Technical Bulletin

Bulletin Number: 415 Revision Number: R-01
Release Date: July 16, 1992 Revision Date: September 4, 1998
SUBJECT: SECURITY SLEEVE; T-HANDLE / STUD
MODELS AFFECTED: See Index
REASON: To combat vandalism to the T-handle lock cylinder / stud area.
NDEX:
All Coke Marketing Machines serialized 0001-6504BW and upPage 2 Cover, T-Handle Bolt 624,050,85x.x3
 All venders with T-handle in coin insert casting
3. Coke Landscape Non-VRV 0001-3023DL to 0001-3233CPPage 6 T-handle Shield 432,010,26x.x3
4. DNCB VendersPage 7

Figure 1

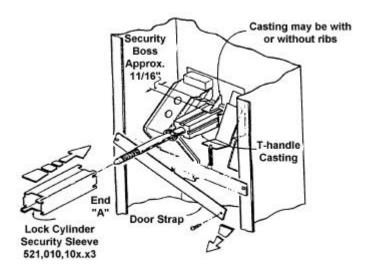
APPLICATION OF LOCK CYLINDER SECURITY SLEEVE TO HORIZONTAL T-HANDLE CASTINGS WITH CYLINDER SECURITY BOSS SHOWN AT APPROXIMATELY 11/16"

- 1. Remove either one of the screws securing the door strap.
- 2. Pivot strap downward to allow installation of lock cylinder security sleeve.
- 3. Position sleeve as shown as slip sleeve over lock casting.
- 4. Pivot strap back to original position.
- 5. Reapply strap screw.
- 6. Door strap may have to be relocated on some units.
- 7. See figure 2 for installed view.

APPLICATION OF LOCK CYLINDER SECURITY SLEEVE TO HOROZONTAL T-HANDLE CASTINGS WITH CYLINDER SECURITY BOSS SHOWN AT APPROXIMATELY 1"

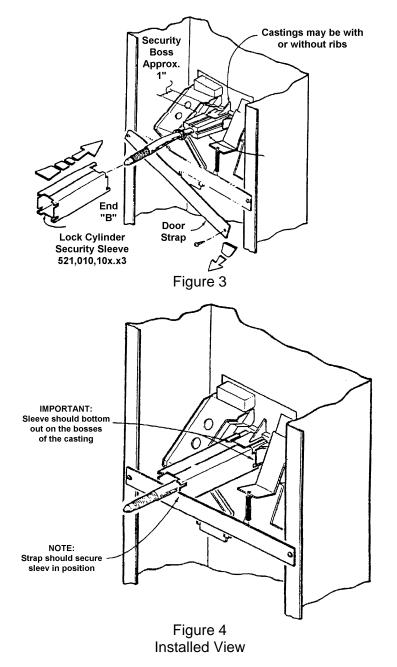
- 1. Remove either one of the screws securing the door strap.
- 2. Pivot strap downward to allow installation of lock cylinder security sleeve.
- 3. Position sleeve as shown and slip sleeve over lock casting.
- 4. Pivot strap back to original position.
- 5. Reapply strap screw.
- 6. Door strap may have to be relocated on some units.
- 7. See figure 4 for installed view.

T-HANDLE SHIELD - LANDSCAPE

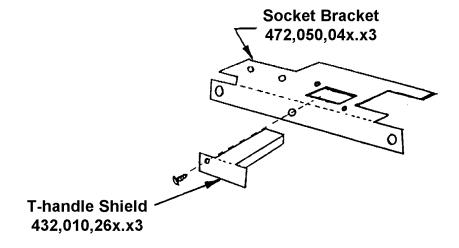
REASON: To shield the threaded stud of the T-handle so the stud will not damage the wiring in that

area.

PART NUMBER: 432,010,26x.x3 T-handle Shield

1. Locate the "bracket" in the main door that houses the changer and vend relay sockets.

2. There is a screw in the bracket's flange. Secure the shield to the bracket with this screw.
